**A.B.P. Ref:** 306977-20

**Proposal:** Proposed Development: 413 no. residential units (182 no. houses, 205 no. apartments), childcare facility and associated site works. Carcur Park, Wexford.

**RE: Report/Response to the Planning Authorities report of the 8<sup>th</sup> of May as requested by An Bord Pleanala 17<sup>th</sup> of June 2020, ABP issued Notice of Pre-Application Consultation Opinion**

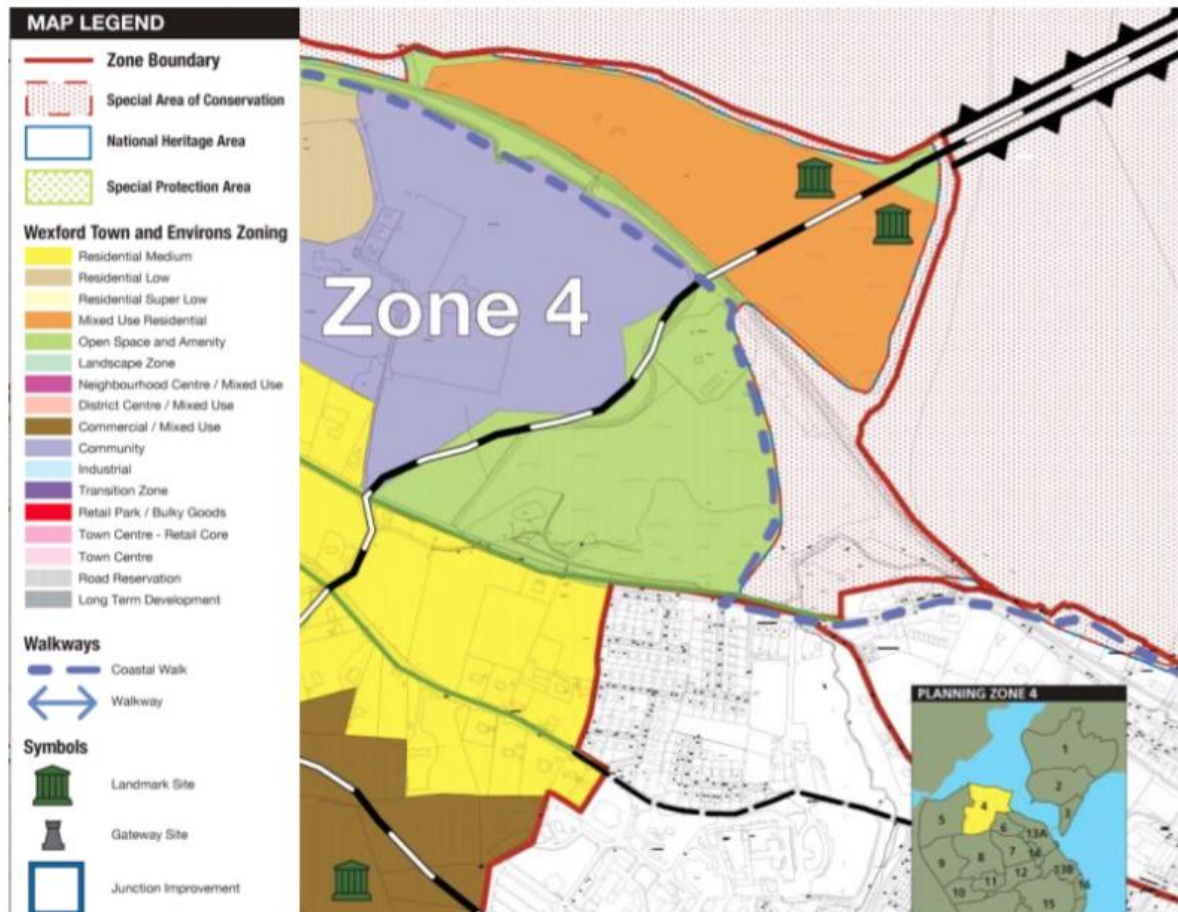
In view of the environmental sensitivity of the site and the adjacent environmental designations, it is the opinion of the Planning Authority that the main bulk of public open space should be provided along the shoreline in order to provide an adequate buffer zone between the development and the SAC / SPA / pNHA. The proposed public open space should be designed so that it is fully integrated and linked into a future riverside walk that would link the proposed site with the town centre.

Open space provision is in accordance with best practice to serve a scheme of this scale. Three large areas of open space are proposed as close to the shoreline as possible. Other areas of open space

are provided at neighbourhood level to serve clusters of housing on an urban block basis.

While the preservation of habitat associated with wintering birds and the protection of the existing otter population take precedent, proximity to the river has been exploited insofar as is possible. A linear park with a bird viewing platform form part of the proposal in addition to walkways through the site with views of the river and estuary. All hard fencing required to protect both the Otter and wintering bird habitats will be suitably screened with planting.

As clearly identified by the zoning and objectives for the subject site highlighted by May 4 of the Wexford Town & Environs Development Plan, The proposed Coastal walk is outside the site boundaries. The proposed development will link with the coastal walk in terms of footpaths and cycle lanes, at the point of access to the site at the proposed railway crossing.
